REFERENCE XXX-EQCOD-EC-XXXX

ENGINEERING CHANGE REQUEST

Improvement of the shielding for the high intensity hadron operation of M2

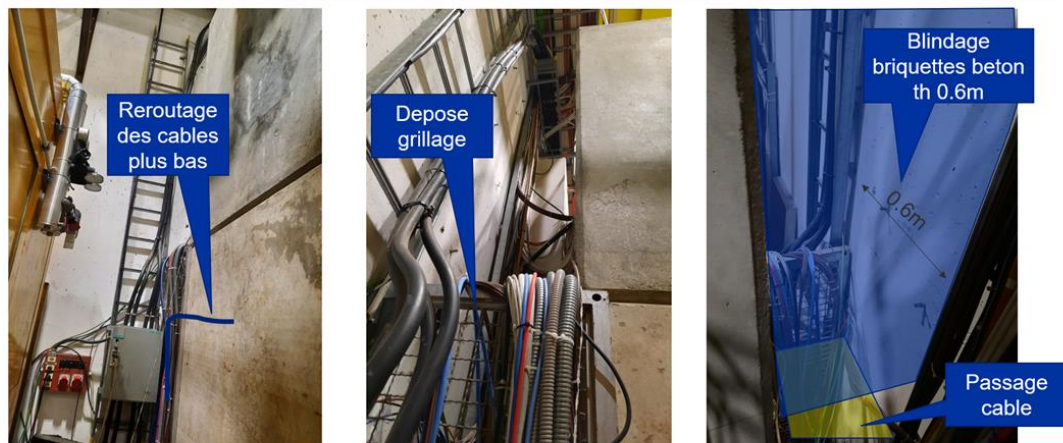
The new shielding configuration at EHN2 aims at keeping the prompt Ambient dose Equivalent in operation in EHN2 within the limit of the CERN Radiation Area classification. In particular, the hall and control rooms are classified as Supervised Area (<6 mSv/year), and the outside of EHN2 as non-designated Area (<1 mSv/year). The objective is also to limit the exposure from CERN installations of members of the public, to values below 10μ Sv/year. Besides, residual dose rate near the target area and should be optimized allowing access after short cool down time to the detector, and air activation properly assessed to comply with CERN Radiation Area classification. The study performed by HSE-RP to assess the radiological impact of a new shielding design for EHN2 is detailed in a dedicated document ([EDMS 2670569](#)).

Figure 3: Improvement of the shielding at the access chicane PPE211
[Update figure with final design including additional block (BE-EA)]

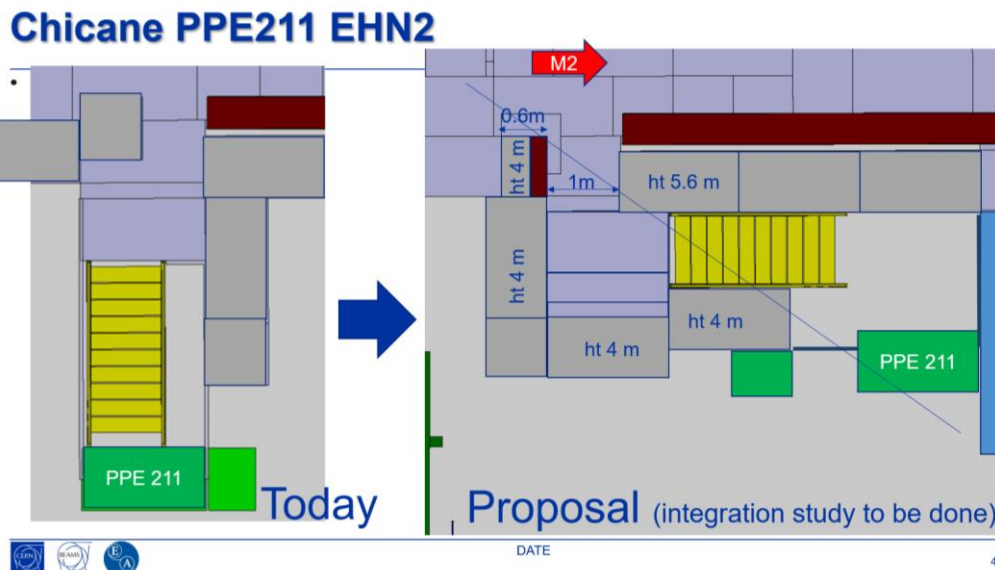
3.2 Access chicane PPE211

The improvement of the shielding at the access chicane PPE211 consist in adding concrete blocks to form a chicane maze, preventing direct view of the M2 beam line from outside the interlocked area (see Figure 3). The objective is to lower the prompt radiation going directly from the secondary beam area to EHN2 hall in case of losses in the region.

[Add detailed description of the works (BE-EA)]

Figure 4: Improvement around AMBER Target of the shielding (AMBER target bunker)
[Update figure with final design including lateral reinforcements (BE-EA)]

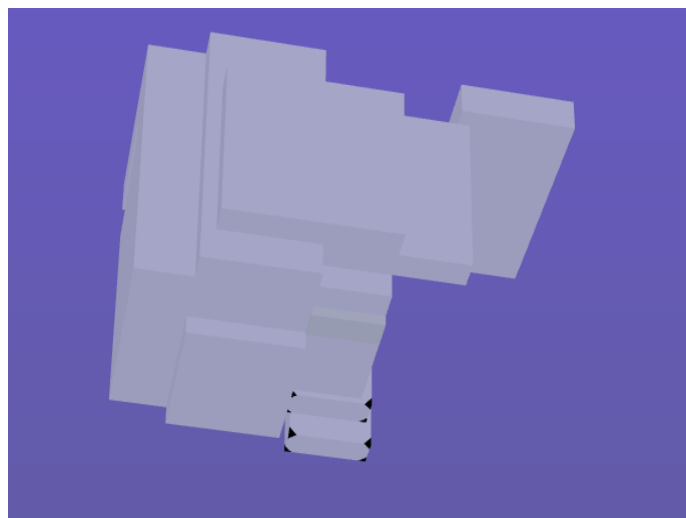
3.3 AMBER target bunker

The improvement of the shielding at the AMBER Target area is to build a bunker made of concrete block around target (see Figure 4) and has two main goals. First, lower the prompt radiation outside EHN2 and mainly due to sky-shine radiation. Second, allow a more optimized access in AMBER experimental area outside the bunker after short cool-down time by lowering the residual dose rate close generated by the targets, minimizing the effective dose received when working in the area. Radiation Area classification inside the AMBER target bunker will depend on the intensity and beam characteristics (see [EDMS 2670569](#)).
